DEVELOPMENT ASSESSMENT REPORT	
Application No.	MOD/2022/0450
Address	2C Gladstone Street NEWTOWN NSW 2042
Proposal	Section 4.55 Modification to DA/2021/1188, modifications include increase total number of residential units from 12 to 16, changes to basement, unit layouts, commercial floor areas, material finishes and detailing of services to roof.
Date of Lodgement	16 December 2022
Applicant	Samcourt Pty Ltd
Owner	The Registered Proprietors Of SP 17149
Number of Submissions	Five
Value of works	\$6,000,000.00
Reason for determination at Planning Panel	Variations exceed 10%
Main Issues	<ul style="list-style-type: none"> • Not substantially the same development • Contrary to the objectives of Zone E3 – Productivity Support • Contrary to Section 4.4 (Floor space ratio) development standard of <i>IWLEP 2022</i> • Contrary to Section 6.22 (Dwellings and residential flat buildings in Zone E3) of <i>IWLEP 2022</i> • Internal amenity of commercial spaces

Recommendation	Refusal
Attachment A	Reasons for refusal
Attachment B	Plans of proposed development
Attachment C	Architectural excellence & design review panel meeting minutes & recommendations
Attachment D	Conditions of consent in the even

Figure 5: Proposed modified plans – cross section and mezzanine/level 1 (GFA highlighted in blue)

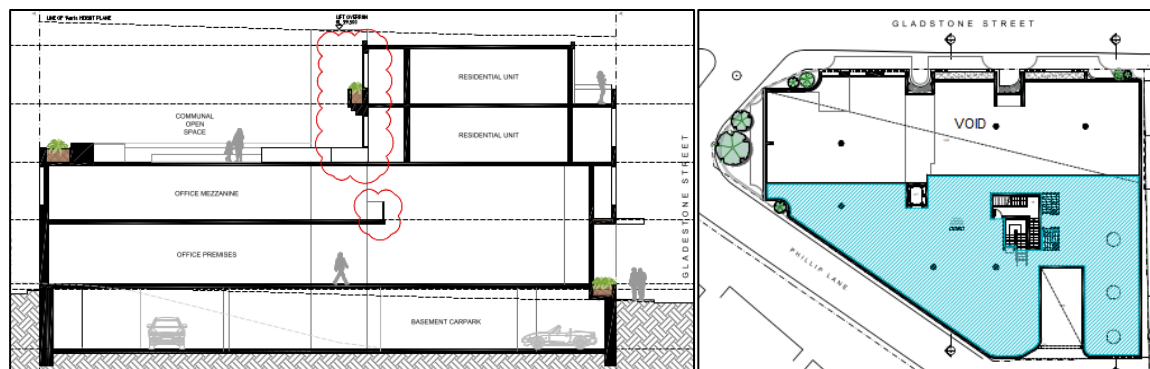
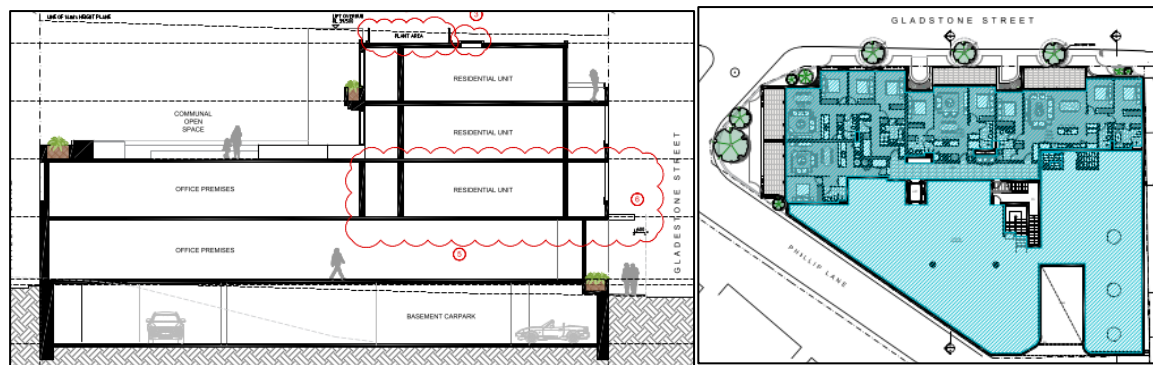
Deletion of the void/double height commercial space

The proposed modifications relate to numerous internal and external changes to the approved building, with the built form remaining largely unchanged and the proposed modifications taking place within the envelope of the previously approved building. Despite this, a key aspect of the approved development is the double height non-residential space on the ground floor (53% of the ground floor area).

As illustrated above, the infilling of the void space with residential apartments results in the removal of the double height (approximately 6.2m) component of the commercial space. The double height commercial space was an important element of the original proposal as it enabled flexibility for future uses by providing an internal height that could accommodate a mix of medium to large format businesses and emerging light industries in accordance with the E3 zone objectives. The modified proposal results in the entirety of the commercial space having floor to ceiling heights of 3.1m on the ground floor and 2.8m on the first floor which significantly limit the nature of businesses capable of operating at the site. Furthermore, the infill of the void results in a floor depth of up to 29m which is detrimental to amenity and viability of both the ground floor and first floor commercial spaces. As such, it is considered that this modification changes a significant material feature and essential component of the original consent and if proposed as part of the originally approved DA would likely have resulted in a refusal.

The modifications increase the number of apartments by 33% (from 12 to 16 apartments) which increases the number of residents and the intensity of the development than that previously approved. As such, increasing the residential component for this development is considered a radical transformation and significant material change and if proposed as part of the originally approved DA would likely have resulted in a refusal.

Figure 7: Proposed height of building exceedance (height plane shown in blue)

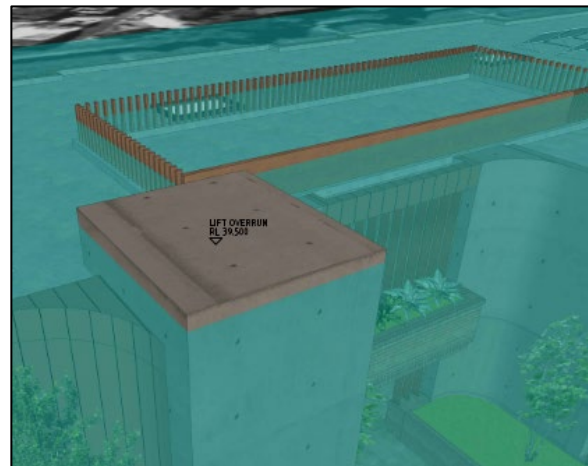
As outlined in the table above, the proposal results in a further variation to the height of building development standard under Section 4.3 of *IWLEP 2022* by 0.46m or 3.3%. The new elements proposed above the height plane include the western set of solar panels, and a ‘screening’ balustrade structure.

It is noted that the base consent was approved with a height of building non-compliance of 0.25m or 1.8% to the lift overrun only.

As noted above, a formal Section 4.6 request is not required, however the SEE provides no justification for the further variation. Whilst a further variation for plant related elements may have merit, the screening balustrade is in close proximity to the roof perimeter and may contribute unnecessarily to amenity impacts such as visual bulk and additional overshadowing.

As such, with the information submitted, if the proposal were to be approved it is recommended that a condition be imposed which requires a minimum 1.5m setback for any additional plant elements to minimise adverse impacts on local amenity in accordance with the objectives of the standard.
